**HARO, KASUNICH AND ASSOCIATES, INC.**

Subject: June 2013 Draft EIR Comments

Reference: Loperena Minor Use Permit/Coastal Development  
 Permit DRC 2005-00216  
 SCH No. 2007081044

Figure 1: Cleath-Harris Geologic Map

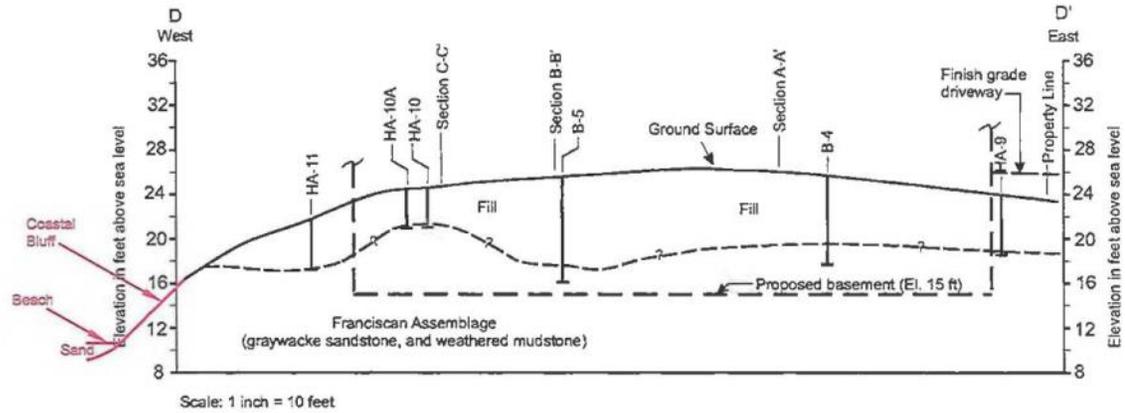
Figure 1 shows Cleath-Harris's Geologic Map of the site that clearly shows exposed bedrock (Franciscan Assemblage Graywacke sandstone) across the entire width of the property along the coastal bluff face, with Beach Deposits seaward of the bedrock.

Figure 2: Cleath-Harris Geologic Cross Section D-D' Modified to Show Coastal Bluff and Beach

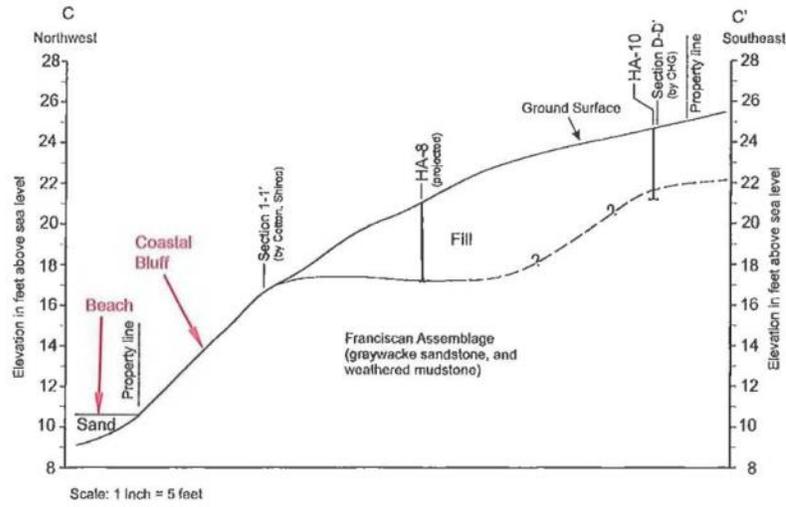
Figure 2 shows Cleath-Harris's Cross Section D-D'. The applicant's geologist (Cleath) terminated this cross section at elevation 16 and did not extend it down the near vertical bedrock coastal bluff face down to the beach. This cross section shows a thin mantle of fill covering the bedrock on the inland portion of the lot. We have sketched an extended portion of the cross section below elevation 16, to show the coastal bluff face and beach that exists there.

Figure 3: Cleath-Harris Geologic Cross Section C-C' Modified to Show Coastal Bluff and Beach

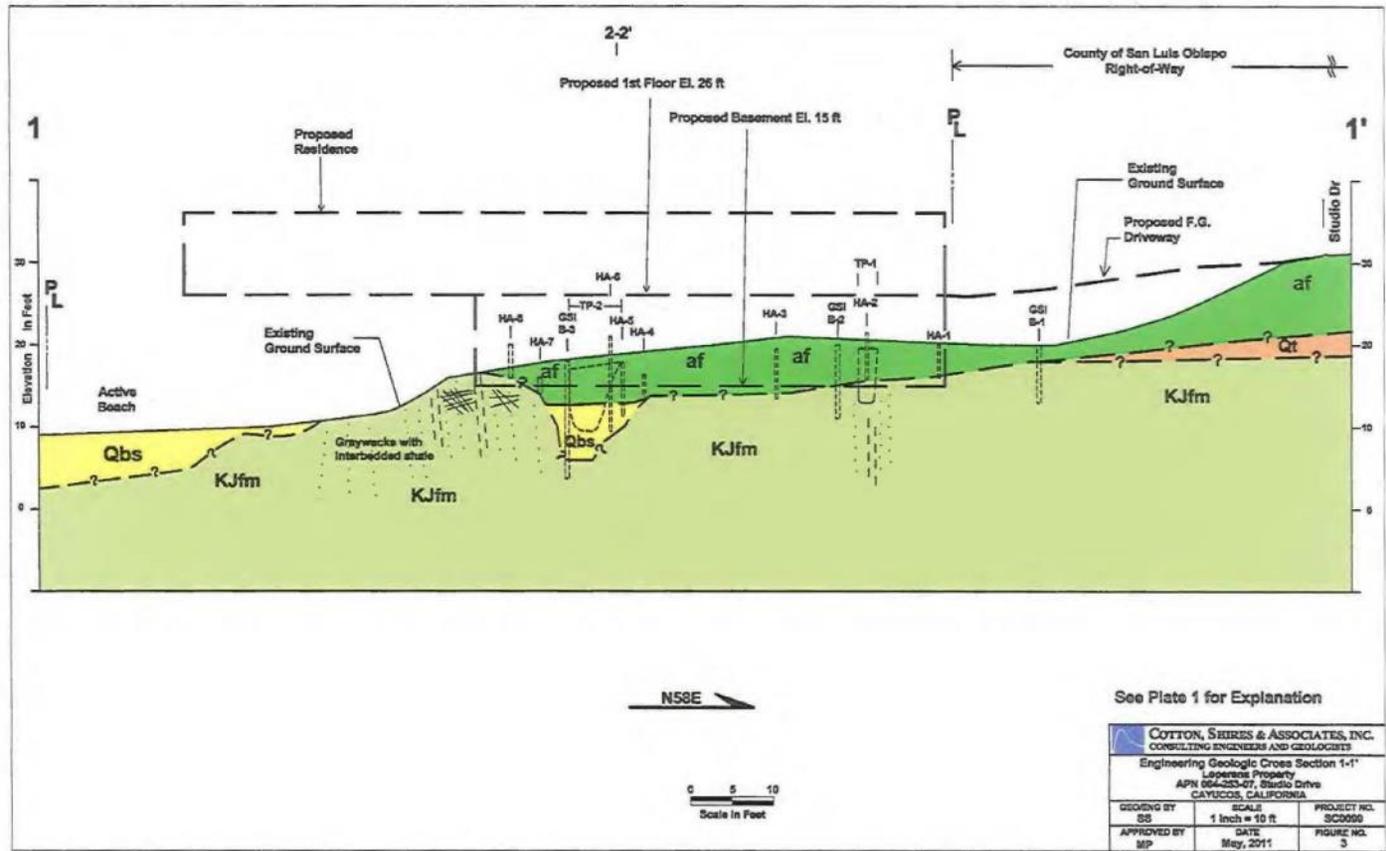
Figure 3 shows Cleath-Harris's Cross Section C-C'. Cross Section C, which is located at the upcoast property boundary, shows that the bluff face is composed of exposed Franciscan Assemblage Bedrock from the sandy beach up to about Elevation 17. The bedrock is mantled by 3 to 4 feet of fill. In fact, as depicted by the applicant's geologist, the bedrock under the fill extends up to elevation 22, and one could argue that the fill is covering what was once the coastal bluff face between elevation 17 and 22. We have labeled the cross section to show the coastal bluff face and beach that exists there.

Figure 4: Cotton Shires Geologic Cross Section 1-1' Showing Proposed Home Extending Over Coastal Bluff and Beach

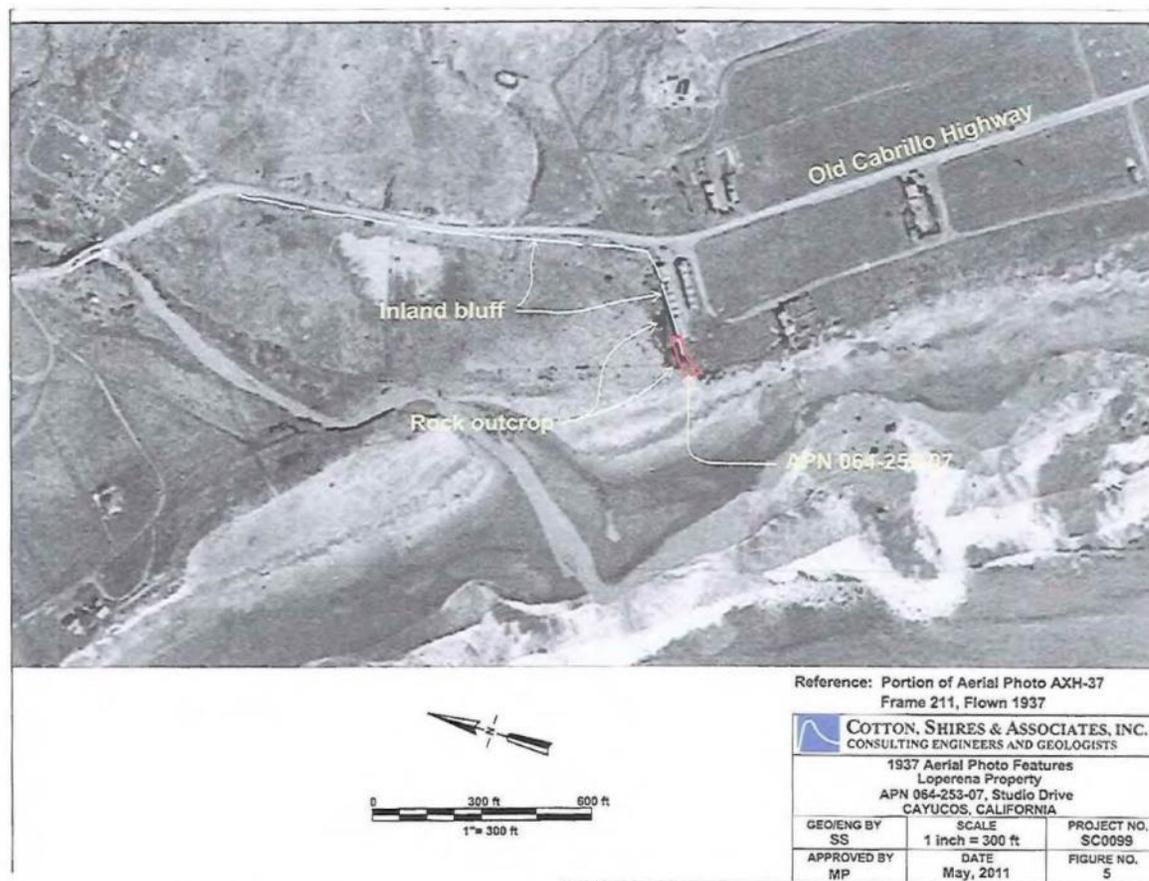
Figure 4 is Cotton Shires Geologic Cross Section which shows the proposed Loperena residence projecting (cantilevered) out over the coastal bluff and what they depict as an "Active Beach". The area between the Active Beach and the landward portion of the residence is the coastal bluff, as defined by the California Coastal Commission.

Figure 7: State of California Acquisition Map from 1955 showing the Toe of Bluff that existed on the Loperena property in 1955

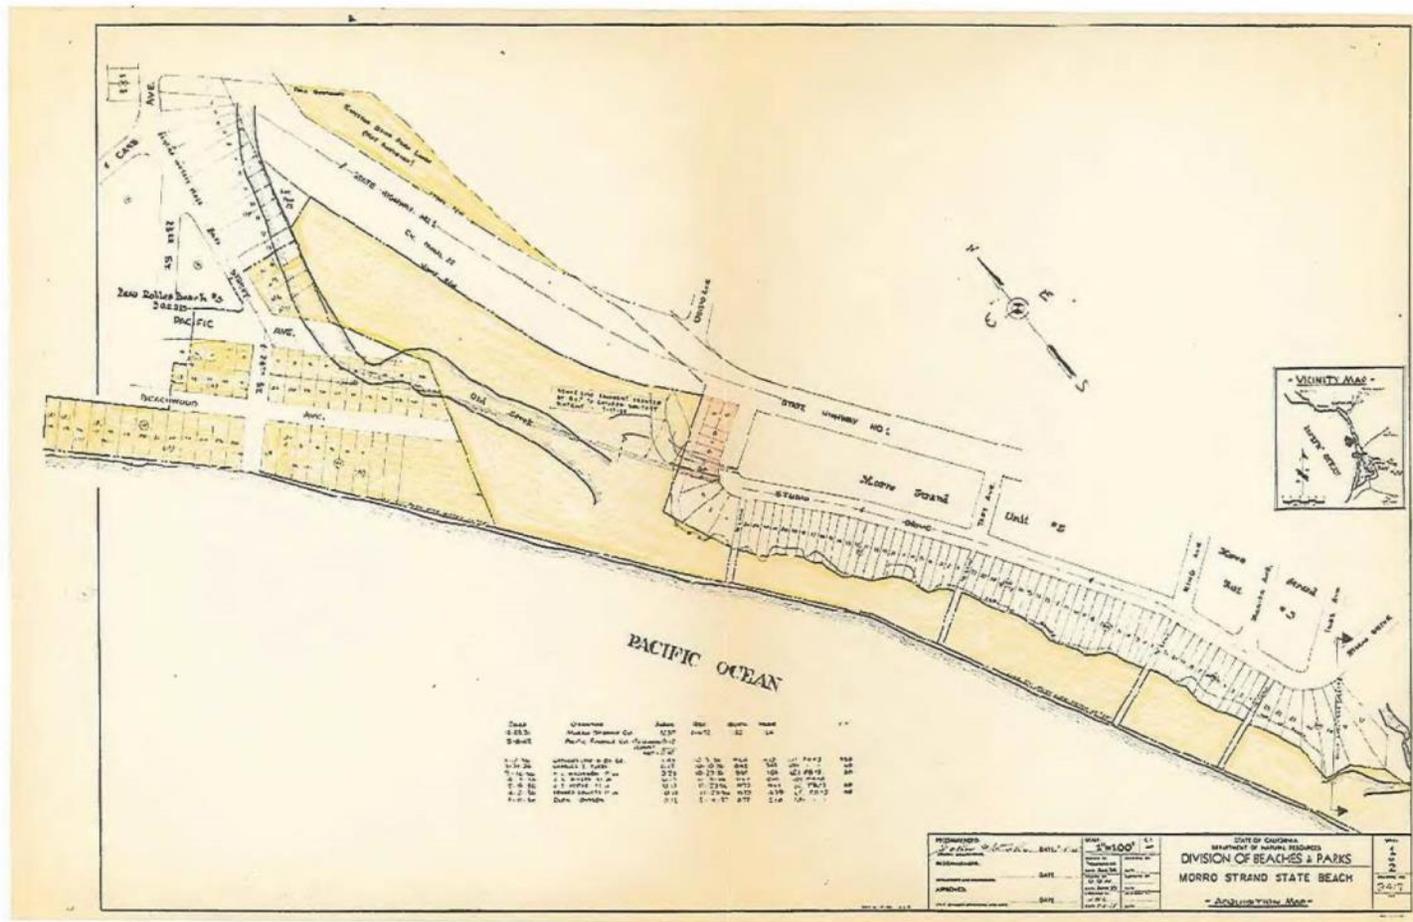
Fortunately, site specific mapping of the bluff was done in 1955. Figure 7 is a 1955 State Of California Acquisition Map for Morro Strand State Beach. This map shows the Loperena property and the bluff configuration at that time. Cotton Shires and Cleath-Harris make no reference to this map (included in this report) in their reports.

Figure 8: Enlarged Portion of State of California Acquisition Map from 1955 showing the Toe of Bluff that existed on the Loperena property in 1955

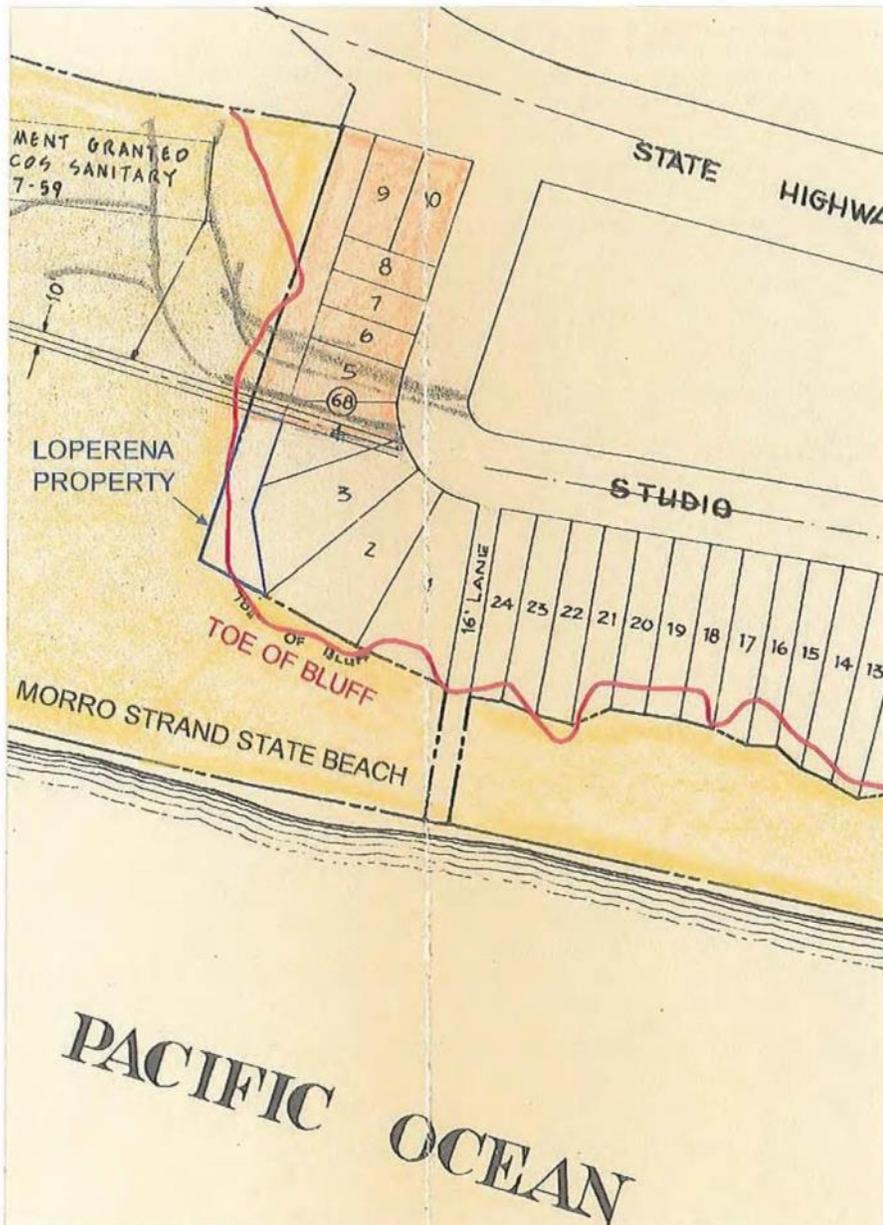
Figure 8 is an enlarged portion of State of California Acquisition Map from 1955 showing the toe of bluff that existed then on the Loperena property. The Loperena property was impacted by both the ocean and creek before Highway 1 was built, and now is primarily impacted by the ocean because the creek's alignment was altered. The map depicts that in 1955 (before Highway 1 was constructed in its present day alignment) it might be considered as a "corner lot", which is within a transition area that is part coastal bluff and part inland bluff. If it was partly a coastal bluff then, and is impacted by coastal processes such as marine erosion, ocean wave run-up, and wave impact today, it should be considered a coastal bluff.

**Photograph 5: Photograph of Flag Study showing Beach and Coastal Bluff**

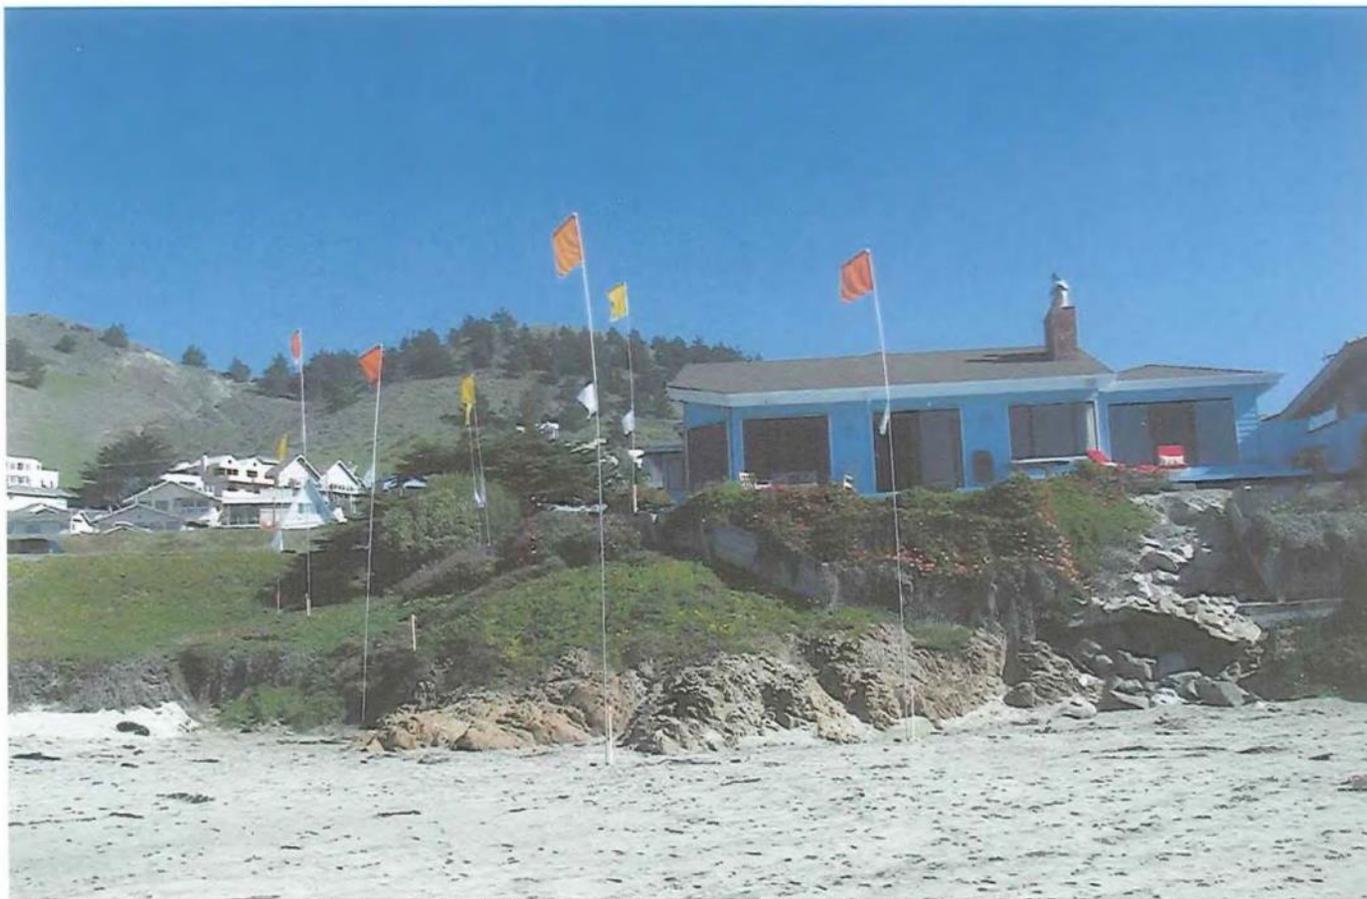
Photograph 5 clearly shows the building extending past the coastal bluff over the beach. The exposed bedrock coastal bluff is shown on the photo. Marine erosion is the process which has exposed the bedrock on the bluff face. The project plans by James Maul-Architect, upon which the plans by C. P. Parker –Architect are based, show that the seaward edge of the home is 14.81 feet from the seaward property line and overhangs the bedrock coastal bluff and the beach. These plans are consistent with the position of
